Re: Abengoa Mojave Solar Project (09-AFC-5): Replacement Written Response to Visual Resources Data Request Set 1B, Item 74 and Information Requested by Tom Packard

Visual Resources

Verbal Requests from Tom Packard

AZIMUTH 255

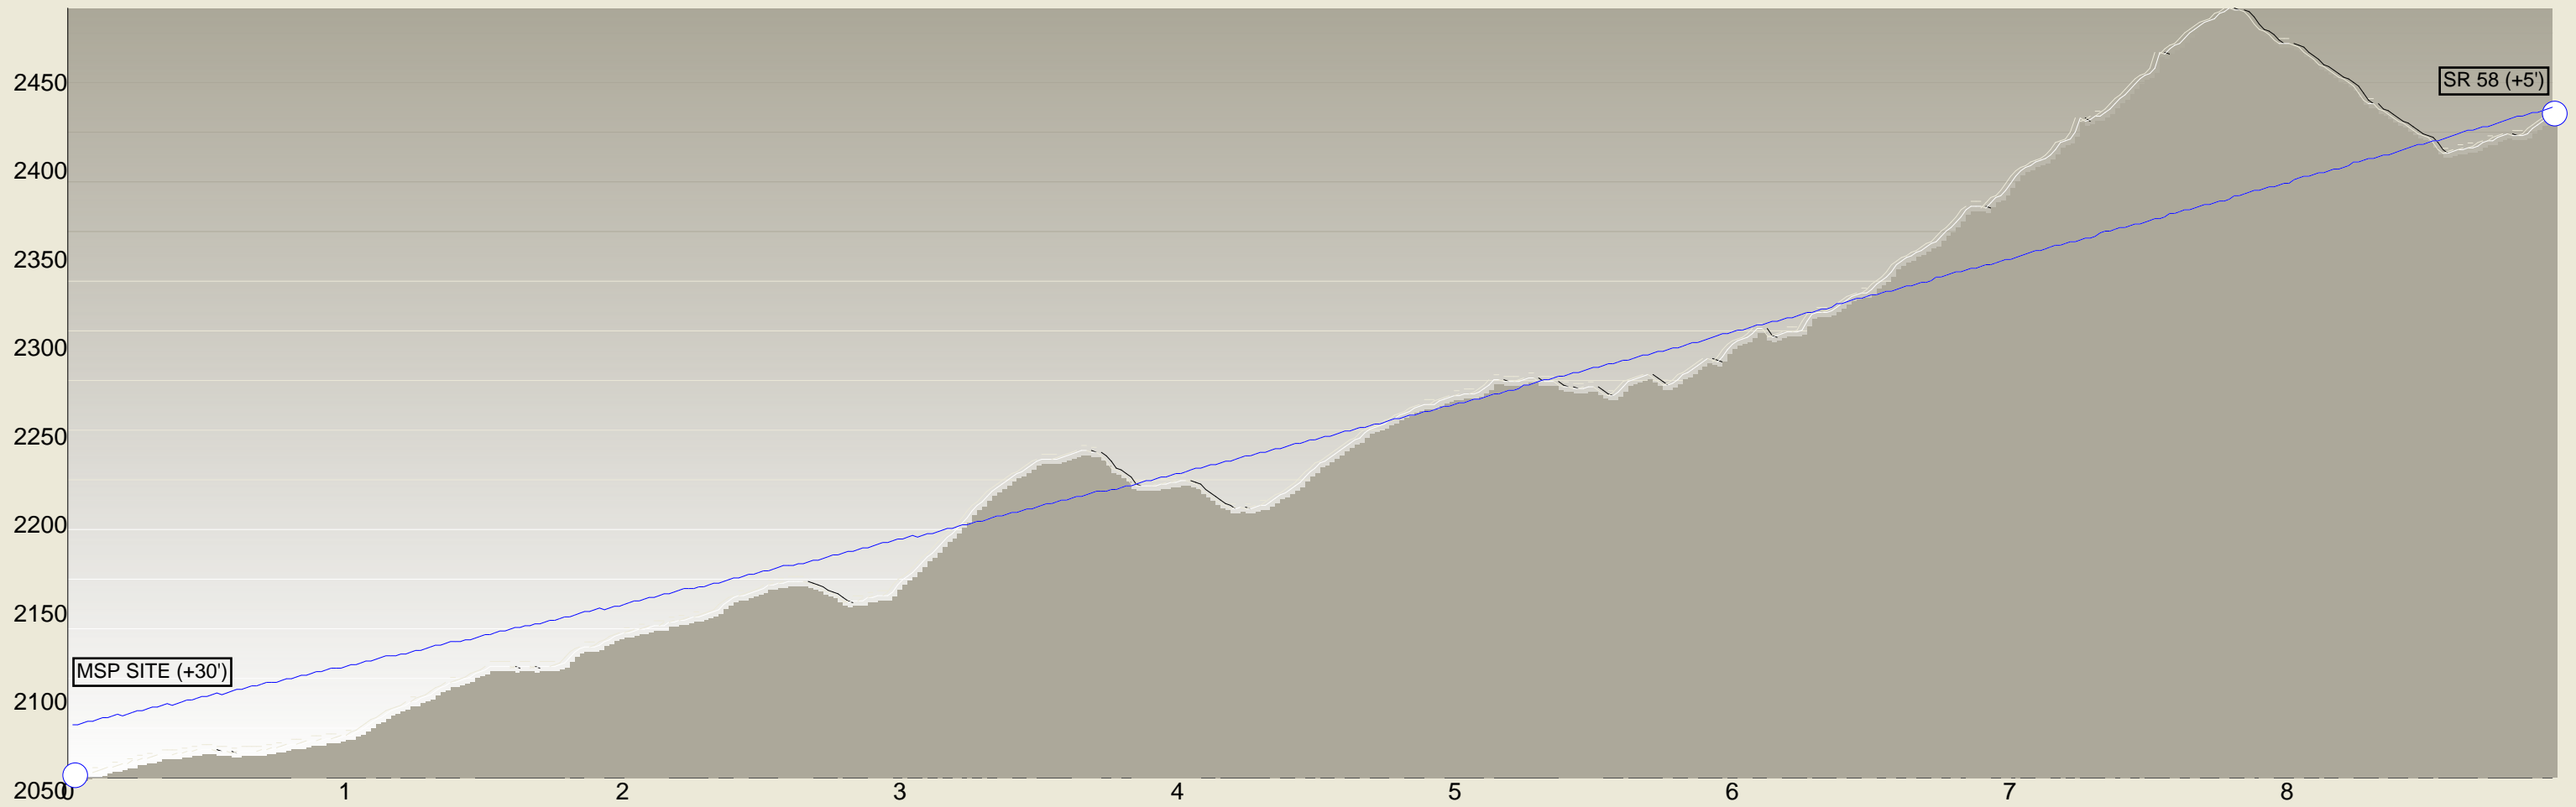
1. Did the visual analysis provided assume a height of finish grade for the analysis? (i.e. did the analysis assume an average height of the equipment?)
2. Did the analysis use USGS mapping?
3. Are there cross-sections available from points along HWY 58 that show the topography obscuring the facility?

1. The analysis used an equipment height of 30 feet above the elevations set for the power islands. This was based upon the mid-point of the tallest structures in the power island area. Then, topography software which is based upon the USGS maps was used to take a cross-section profile at 15 degree azimuth increments around the project site and out to a 15-mile radius.

2. Yes, the software employed is based upon USGS mapping.
3. The following pages contain a base map and cross sections at 15 degree intervals between Highway 58 and the project site. Lines of sight are shown on the cross sections to clarify where topographic visual barriers exist between the highway and the site. The lines-of-sight were set at 30 feet above power island grade at the plant site, as noted previously in response 1, and at 5 feet above road surface on Highway 58 to account for the height of the viewer. Note that the lines-of-sight shown are not straight, but curved to take into account the curvature of the earth over this extended sight distance.
